PLANNING APPROVAL STAFF REPORT**Date: October 4, 2007****NAME**

Nazaree Full Gospel Church

Planning Approval to allow a private school in a B-3, Community Business district.

SITE PLAN

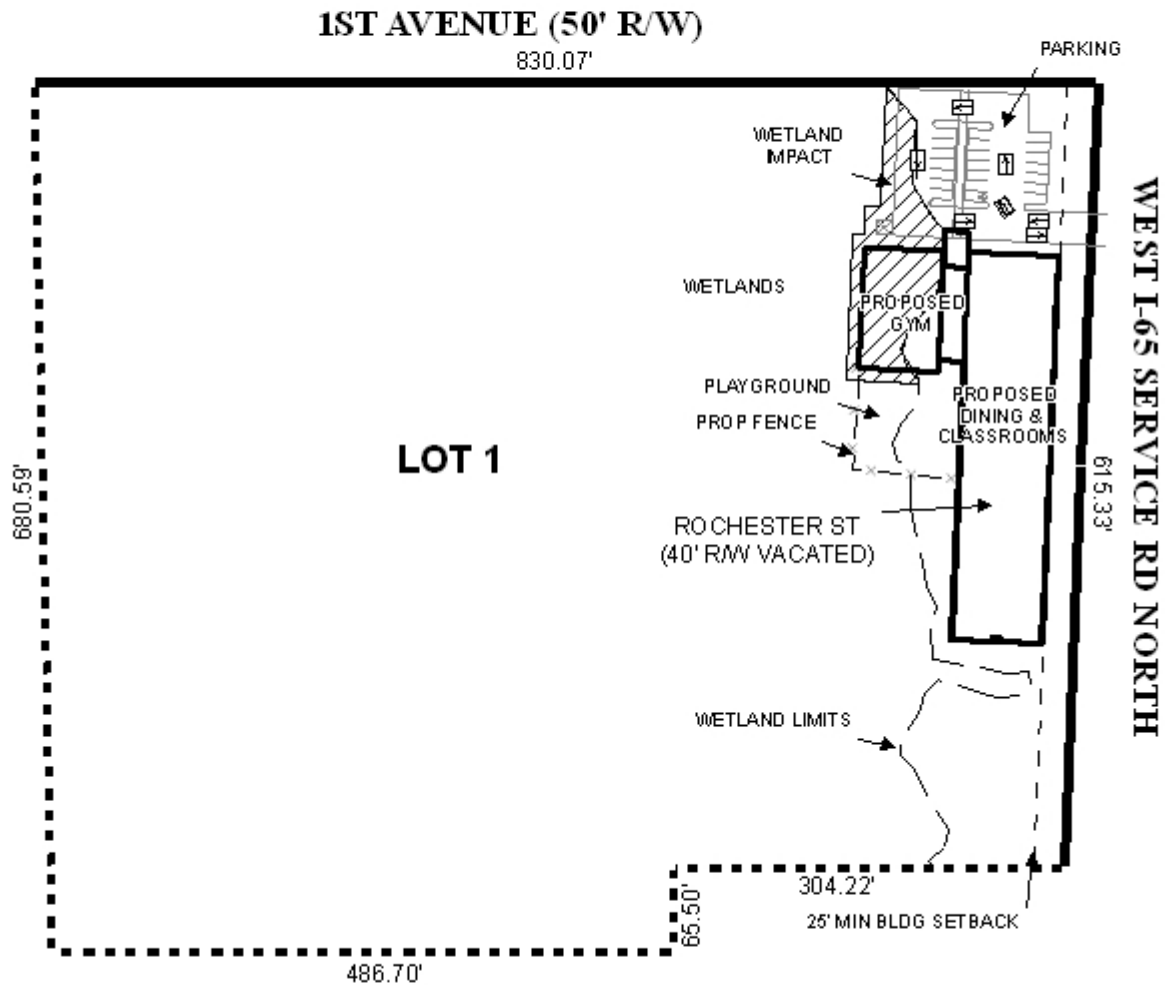
Regarding the school use itself, Planning staff needs additional information regarding the proposal, specifically, the number of teaching stations: six classrooms are proposed, however, there are instances when multiple teaching stations are provided within one classroom. Parking requirements cannot be determined without teaching station information.

The site plan appears to depict a building that will be approximately 33,000 square feet in size. Due to the layout of the structure, it appears that there will be other uses besides classrooms on the site, however, no information is provided. More detailed information should be provided regarding other uses, such as gyms, cafeterias, etc., so that staff can understand the extent of the proposal. Furthermore, no information is provided as to the number of floors that will be provided in the structure. Staff also assumes that there will be an outdoor playground area, and that the area will be fenced: the site plan should depict the general location of the playground area and if fencing will be provided.

Staff anticipates that the vehicular circulation on the site will be problematic as it relates to the drop-off and pick-up of children. Only one sidewalk within the parking area is implied, however, additional sidewalks might be beneficial in the parking area due to the age of the children that will be walking in the parking area. Staff also anticipates that traffic cues may cause congestion that will back into the service road right-of-way. Also, the site plan does not depict the connection of the parking area to the service road – no curb radius is indicated.

Storm water detention may be required for the proposed development, however, no storm water detention facilities are depicted on the site plan. Furthermore, the site appears to be located within the 100-year floodplain associated with Three Mile Creek and its tributaries. Wetlands may also be present on the site. The potential presence of wetlands and floodplains indicate that the area may be environmentally sensitive; therefore, the approval of all applicable federal, state and local agencies would be required prior to the issuance of any permits or land disturbance activities

Finally, the site plan does not depict compliance with the tree and landscaping requirements of the Zoning Ordinance, however, full compliance will be required. No sidewalk is depicted along the Interstate 65 service road, however, a sidewalk will be required unless an application is made for a sidewalk waiver.

The revised information includes an expansion in the number of classrooms, students and teaching stations proposed for the site, yet it appears that the building size is not being changed. The original application proposed 6 classrooms and up to 144 students. The revised information states that there will be 11 teaching stations, 10 classrooms, and a maximum of 220 students. The revised site plan includes a floor plan of the one-story building showing 10 proposed classrooms, a gymnasium, media room, administrative offices, dining facility and kitchen. A 20-space parking lot with drop-off circulation route, dumpster location, and playground with fence are also depicted on the site plan. Trees and landscaping are not depicted on the site plan, however a note on the plan states that a landscape plan that complies with the requirements of the Zoning Ordinance will be submitted for review as part of the building permit procedure. Another note on the plan states that the site will be built in compliance with the 2003 International Fire Code, including appendices B through D, as adopted by the City of Mobile. Storm water detention facilities are not depicted on the site plan, but may be required by the Engineering Department.

Traffic along the service road will be increased due to the school, and it is possible that traffic along the service road will be slowed or stopped due to turning movements into and out of the school. Staff also believes that there may not be adequate stacking or parking area for parents dropping off or picking up children, however, the number of parking spaces being provided does comply with the minimum requirements of the Zoning Ordinance.

Planning Approval: Based upon the preceding, this request is recommended for Holdover until the November 1st meeting, with revisions due by October 15th, so that the following items can be addressed:

- 1) provision of additional information regarding the use of the building, including a preliminary floor plan indicating classroom areas and other uses;

- 2) provision of additional information regarding the number of teaching stations, if different than the number of classrooms;
- 3) revision of the site plan to show the parking area connecting to the service road, with the appropriate radius for the connection;

- 4) provision of information regarding the drop-off and pick-up procedure, specifically explaining if it will be drop-off or park and walk-in with the children;

- 5) revision of the site plan to depict the general location of any outdoor play areas and any fencing that will be provided;
- 6) consultation with the Mobile Fire-Rescue Department to determine if the building layout and site plan meet the requirements of the 2003 International Fire Code, as adopted by the City of Mobile, and revision of the site plan if necessary to comply with the comments (*All projects must comply with the requirements of the 2003 International Fire Code, including Appendices B through D, as adopted by the City of Mobile, and the 2003 International Existing Building Code, as appropriate. Building and site design shall specifically comply with 2003 IFC Section 503.1.1 buildings and facilities. Fire apparatus access roads shall extend to within 150 feet of all portions of the facility and all portions of the exterior walls of the first story of the building as measured by an approved route around the exterior of the building or facility. May require an automatic sprinkler system and Commercial hood with automatic fire suppression system.*);

- 8) depiction of the general location of any on-site storm water detention;
- 9) revision of the legal description on the site plan to reflect the recorded plat;

- 10) revision of the site plan to clearly depict the building location;

- 11) revision of the site plan to depict a sidewalk along the service road, or submittal of an application for a sidewalk waiver; and
- 12) revision of the site plan to depict compliance with the tree and landscaping requirements of the Zoning Ordinance.

- 1) Changes to the scope of operations that increase the number of students beyond 220 students, the number of teaching stations beyond 11 stations, the hours of operation beyond 6:00 AM to 6:00 PM, or that result in significant changes to the size and location of buildings and parking will require a new application for Planning Approval;*
